Bedroom 1's bathroom · design review F-05 · accept the route (A) or a private bathroom (B)? · Taif / Palm House V8.1 · STUDY ONLY

OPTION A ADOPTED by the owner (2 Nov 2026): no private bathroom; the wet areas stay grouped in the two clusters; night lights along the route. 2 Nov 2026, after the stair flip (option B, F-b) · bedroom 1 is the north-east room over the maid wing, 15.75 m² on axes, 13.9 m² clear, one room without a bath · nothing in the design files changes until the owner decides · all sizes assumed

bedroom 1 · A · 1 m = 0.95 cm · north up · brown dotted = the ground floor below

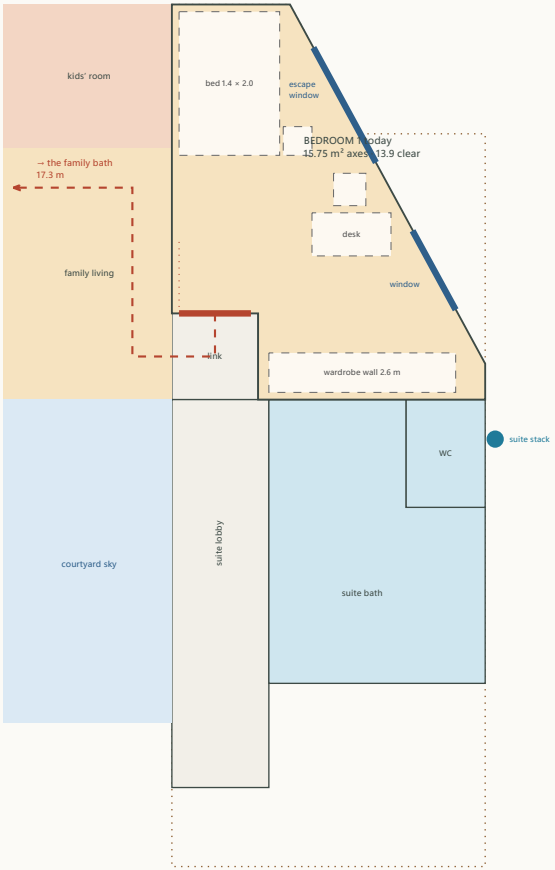
- **The walk, measured after Part 1** (the stair flipped, the family bath enlarged northwards; its door stays at x 4.25, y 9.3–10.3): bedroom 1's door → the family link → the family living, behind the sofa → the gallery's north part, past the stair arrival → the gallery → the bath's door: **17.3 m** (the same as before the flip: the bath grew, its door did not move). Five spaces, two of them lived in (the living, the gallery).

- **Who shares the family bath:** bedroom 1 (17.3 m), bedroom 2 (2.7 m), the kids' room and the family living (a bedroom later); bedroom 3 and the suite have their own. Since F-b it has **two compartments** (a WC by the shaft and the shower + double basin), so two children at once.

- **Comfort:** a child or a guest in bedroom 1 crosses the **family living** at night and in the morning, in sight of whoever is there; 17 m is the longest bathroom walk in the house (the suite's is 0, bedroom 3's 2.7, bedroom 2's 2.7).

- **Cost:** nothing; the plumbing stays as it is.

bedroom 1 · B2 · 1 m = 0.95 cm · north up · brown dotted = the ground floor below

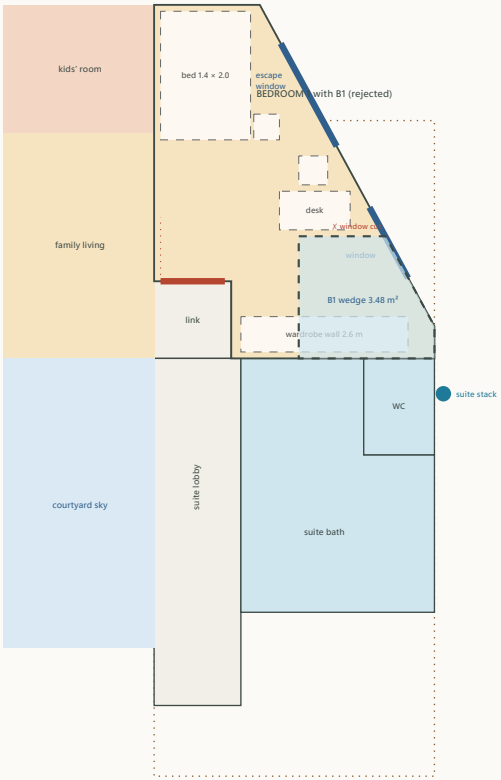
- **B2 (the best, drawn):** a bath along bedroom 1's **south wall**, x 10.6–13.311, y 5.0–6.5, its east end following the cut wall: **3.79 m² on axes, 2.49 × 1.3 clear less the slant ≈ 3.0 m²**: a walk-in shower 0.9 × 1.2 at the east end (its corner 0.02 m west of the cut wall), the WC in the middle facing north, the basin on the west wall, a **sliding 1.0 m door** from the room (no swing), a **small window on the cut wall** (y 5.35–5.85, sill +1.60, obscured). It is **next to the master suite's wet stack**: the pipes run 2.5 m east in the bath's own floor zone to the suite's stack outside the east wall (y 7.05), **over the GF maid room only** (the kitchen and its hood zone start at y 7.0; nothing over the master bedroom).

- **Bedroom 1 with B2: 11.96 m² on axes, ≈ 10.3 m² clear** (was 15.75 / 13.9): the bed 1.4 × 2.0 stays on the west wall with its bedside table, the desk and chair under the escape window, the wardrobe wall (2.6 m) becomes **two wardrobes, 1.3 m on the bath's wall and 0.9 m on the west wall** (2.2 m in all); the door's swing stays clear; the **escape window stays the room's** (the fire study unchanged); the second window (y 4.15–5.25) lights the desk. Still a full bedroom (a 1.4 bed, a desk, 2.2 m of wardrobe), no longer a two-bed room.

- **Drain:** the shower, the WC and the basin to one branch running east along the bath's south side to the **suite's stack** outside the east wall (y 7.05), 2.5 m; the branch crosses the room's south wall line at x 13.311 and turns south outside the wall for 0.6 m (or a second stack beside the suite's; the MEP engineer). **Over the GF maid room only**: not over the kitchen (y ≥ 7.0), its hood zone (the east wall y 10.2–11.2) or the master bedroom (x 8.95–13.311, y 11.9–19.25).

- **Structure (`studies/structure.typ`):** the maid wing's first-floor bay is a **solid 0.20 slab** spanning east–west 4.36 m to the cut wall; a 0.15 depressed zone cannot be cut from 0.20. Two ways, the engineer's choice: **(i)** cast the bay 0.35 thick under the bath with its top depressed 0.15 (as the suite bath, X10), or **(ii)** keep the slab and run the pipes **below** it in the maid room's ceiling void (the maid room gets a gypsum ceiling anyway; 3.1 m clear left) with a wall-hung WC and a shower tray raised ≈ 0.10. The bath's walls are light partitions on the slab (no beam; B6 at y 6.5 is the room's south wall beam, untouched).

- **Windows:** the bath's small window on the cut wall faces the lane side (obscured glass, a vent); the room keeps both its windows. **Ventilation:** the window plus an extract fan to the roof riser is not available here: an extract through the cut wall (a small louvre) or a duct in the ceiling void to the east wall.

- **Neighbours:** the maid room below hears the bath (pipes in a ceiling void: wrap them); the suite's WC closet shares the stack; the family link and the suite lobby are untouched; the family bath keeps serving bedroom 2, the kids' room and the living.

Recommendation: B2, if bedroom 1 is to be a guest room or an older child's room; otherwise A

- The route is the longest in the house and crosses the living: that is the real cost of A, and the only one. B2 answers it for ≈ 3 m² of the room and one more wet room; it is the only tidy position (B1 is a wedge that cuts a window, B3 takes the escape window). **Conditions for B2:** the engineer chooses the slab detail (i) or (ii); the MEP engineer the stack connection and the vent; the wardrobe split accepted.
- **If A:** keep the family bath as F-b (two compartments) and note in the house rules that bedroom 1's user has the family bath; nothing else to do.

bedroom 1 · B1 · 1 m = 0.95 cm · north up · brown dotted = the ground floor below

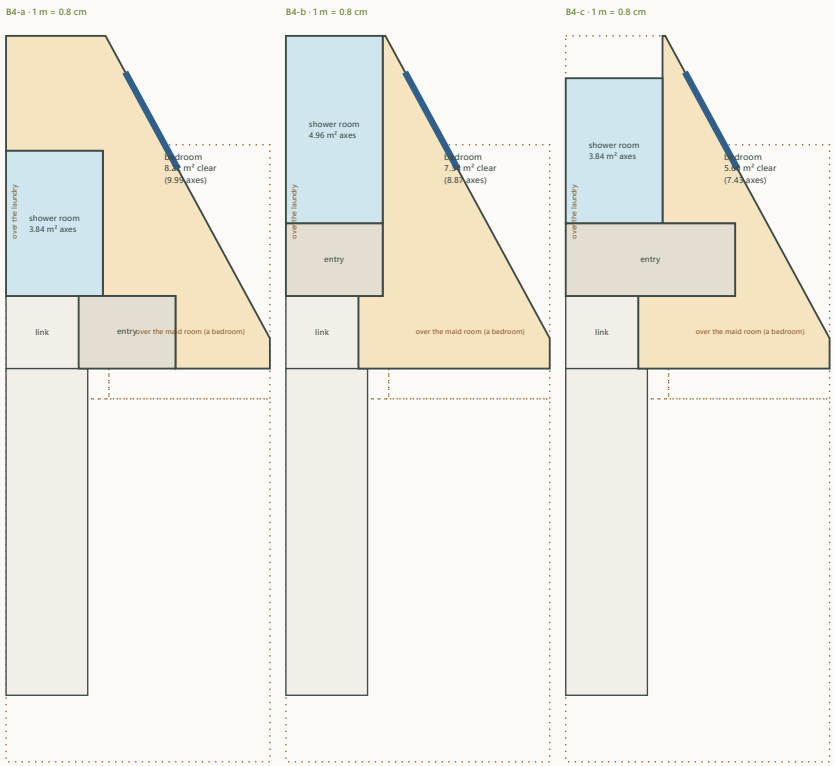
- **B1 (the south-east wedge, dashed on page 2):** x 11.2–13.311 on the cut wall, 3.48 m²: a wedge, its north wall cuts the second window (y 4.15–5.25) and leaves 0.8 m of the wardrobe wall: worse than B2 for the same plumbing. **B3 (the north-east corner):** the north-east corner (x 10.6–12.0, y 1.0–2.9) holds the room's **escape window** and the bed's head wall: a bath there moves the escape window and the bed; rejected without drawing.
